18th September 2015

SITE 8C, SYDNEY OLYMPIC PARK - PROPOSED MODIFICATIONS TO APPROVED DEVELOPMENT RESPONSE TO SUBMISSIONS

Figure 1: Elevation and Section of Proposed Portico (including indicative NRMA signage)

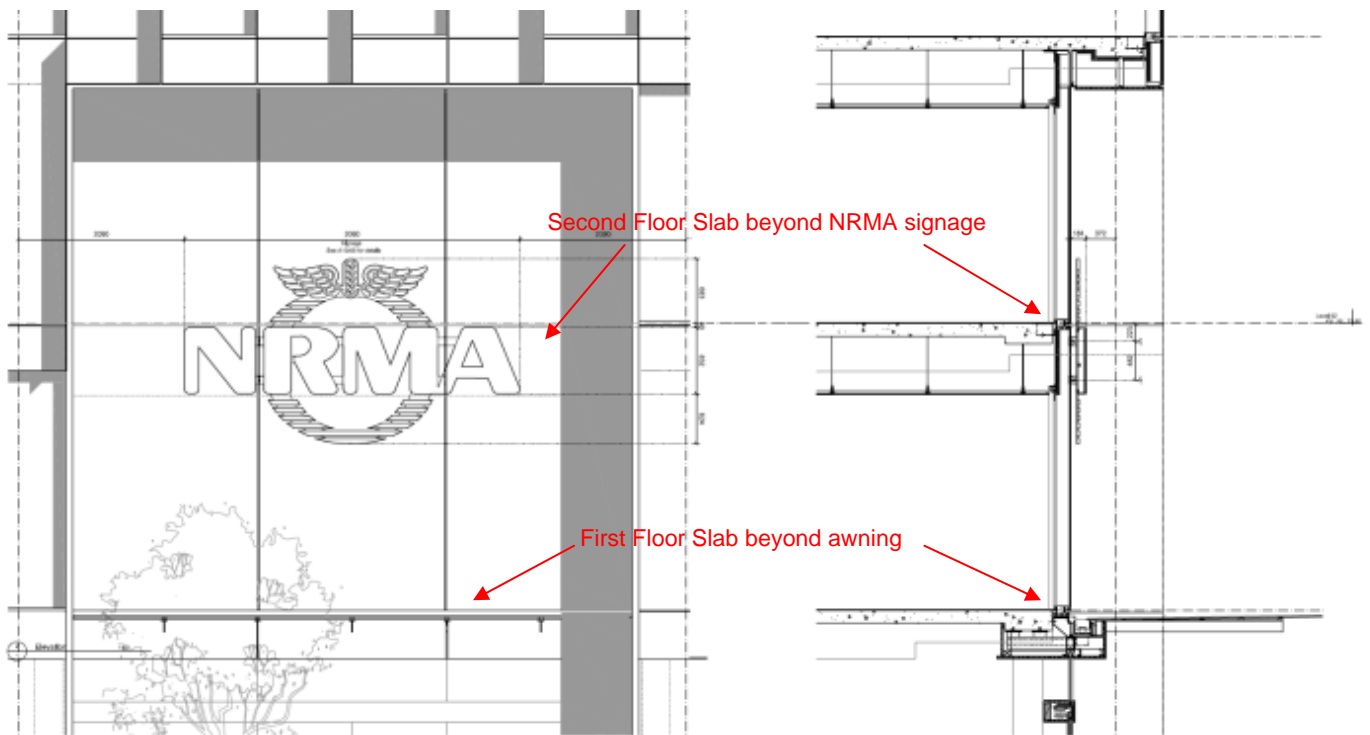
- *That the first and second floor slabs extended directly to the back of the portico. Ideally there should be a 3 storey high void to reinforce the scale impact of the portico.*
- *That new voids separating internal floors had not been coordinated with the facade design changes.*
- *That replacing half of the ground level tenancies with NRMA retail may deactivate the frontages if not properly fitted out.*
- *No further consideration of the 'green roof' recommended at the last DRP, however it was noted that one of the modifications is a roof deck proposed for staff.*
- *The finish to the top of the glazing*
- *Continuity of the character of the street awnings with adjacent development*

- *The first and second floor slabs (and edge beams) be set back from the portico. Ideally the new voids should be aligned to create a 3 storey atrium behind the portico, but at the very least a metre set back from the glass is recommended.*
- *The ground level NRMA fitout should present an active and vibrant frontage to the street – i.e. no blinds, joinery fixtures or furniture against the glass.*
- *Glazing at ground level should be frameless if possible, or with mullions at maximum spacing.*
- *A green roof be considered in conjunction with the new roof terrace.*

The DRP's recommendation for a three storey atrium behind the portico is inconsistent with NRMA's required operational layout and will significantly affect their proposed internal fitout. Despite the DRP's concerns, FDC believe that the slab edge will not result in an unreasonable architectural outcome on the basis of the following points:

- The first floor slab edge sits immediately behind the proposed awning. The slab edge, although hidden behind colour backed glazing, will also be hidden by the lineal element of the awning for the entire length of the façade and within the portico. Furthermore, the slab will provide structural support to the awning, suggesting that its position immediately behind the glazing is more appropriate than providing a one metre setback;

- The second floor slab band, again positioned behind colour backed glazing, is again subtly lost from view behind the proposed indicative NRMA signage which sits immediately in line with the slab edge (Please note, the NRMA logo may be subject to change – current logo provided only to illustrate proposed signage zone and intent of entry feature signage);

For these reasons, the proposed portico will remain as currently proposed. We do not agree that a three storey internal atrium is necessary to improve the external appearance of the proposed portico.
